SYDNEY WESTERN CITY PLANNING PANEL (Sydney West)

Panel Reference	2018SSW008
DA Number	DA-109/2018
LGA	Liverpool City Council
Proposed Development	Demolition of existing buildings, consolidation of lots and construction of a 6-storey residential flat building comprising 9 x 1 bedroom units and 33 x 2 bedroom units with at-grade car parking. The development is lodged pursuant to the State Environmental Planning Policy (Affordable Rental Housing) 2009 and is to be managed by a social housing provider.
Street Address	87, 89 and 91 Nuwarra Road, Moorebank
Applicant	GAT and associates
Owner	St George Community Housing Limited
Date of DA lodgement	13 February 2018
Number of Submissions	Six (6) objections have been received
Recommendation	Approval, subject to conditions of consent
Regional Development Criteria (Schedule 4A of the EP&A Act)	The proposal is for an affordable housing development that has a capital investment value of over \$5 million, the Sydney Western City Planning Panel is therefore the determining authority.

Report prepared by	Boris Santana
Report date	5 November 2018

Figure 7 – Extract of the section plan showing the building elements which exceed the height limit.

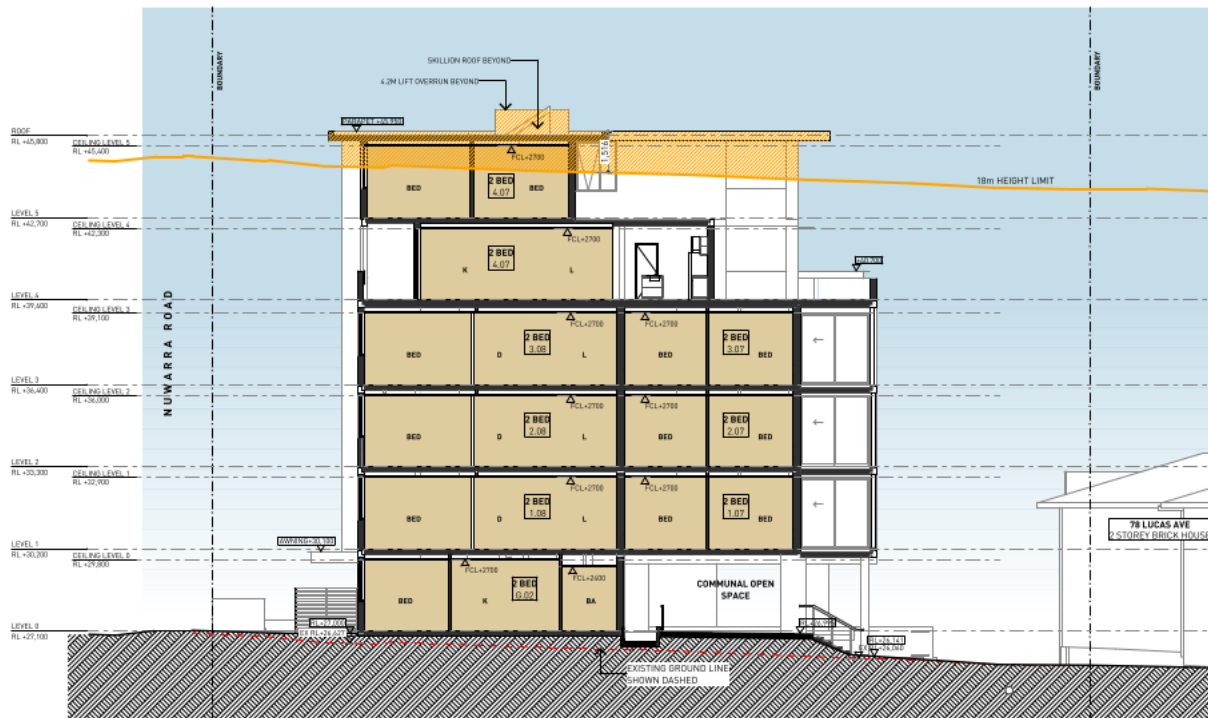
The development proposes a maximum height of 19.8m to roof slab which represents a numerical variation of 1800mm or 10% and a maximum height of 20.3m to lift overrun which represents a numerical variation of 2300mm or 13%. As demonstrated below, the non-compliant height relates to a portion of level 5 of the development and lift overruns.

Consequently, the applicant has provided a clause 4.6 variation to justify the non-compliance. The submitted written request to vary Clause 4.3 - height of buildings has been assessed against the provisions of Clause 4.6; the objectives of the Clause being varied; and the objectives of the R4 zone, are discussed below:

In response to the applicant's submission, Council accepts that strict compliance with the applicable height control is unreasonable and unnecessary having regard to the following:

- The height of the ground floor level of the development above the natural ground level ranges from 100mm to 800mm as per the topography of the site which slopes in a north-westerly direction. The height of the ground floor level, which has been set as a result of the drainage design of the development, contributes to the proposed breach in the height limit. The submitted stormwater concept plan indicates that stormwater runoff from the proposed development will be captured at the front of the site and discharged via gravity to the existing drainage easement at the rear of the site. Considering this, a reduction to the ground floor level of the building so as to negate any breach in the maximum height limit, will require the applicant to significantly excavate the natural ground floor level at the front of the site. It is considered that such a design is not ideal as excavation of the natural ground level would result in a development whereby the ground floor level is lower than the street level, which is considered to detract from the streetscape. In the circumstances, it is considered that the height of the ground floor level is suitable for the purpose of achieving adequate stormwater drainage of the proposed development and so the ground floor adequately addresses the streetscape.

- The plans show that the largest height exceedance is towards the north of the site where the topography descends by at least a metre. Although the southern end of the building also varies the 18 metre height limit, it is notably less than that proposed to north of the site. Therefore, as the development responds to the sites topography, the height of the building minimises the additional length of shadow cast to adjoining neighbours to the south. Shadow diagrams have been submitted that shows the impacts of the proposed development to the southern neighbour is negligible compared to a complaint scheme.

- The subject site accommodates a six storey building which is characteristic of development that is to be anticipated in a zone that permits a height of buildings of 18m. The breach in height limit mainly stems from the proposed drainage system as well as additional floor to ceiling heights. In order to achieve a compliant building height, it is necessary to delete the fifth floor level of the building thereby reducing the dwelling yield of the development and possibly the amount of affordable housing onsite; or retaining the development yield but not without substantial changes to the building design which may result in an inferior design outcome. In this case, it is considered that there is adequate environmental grounds to support a variation to Clause 4.3 of the LLEP 2008.
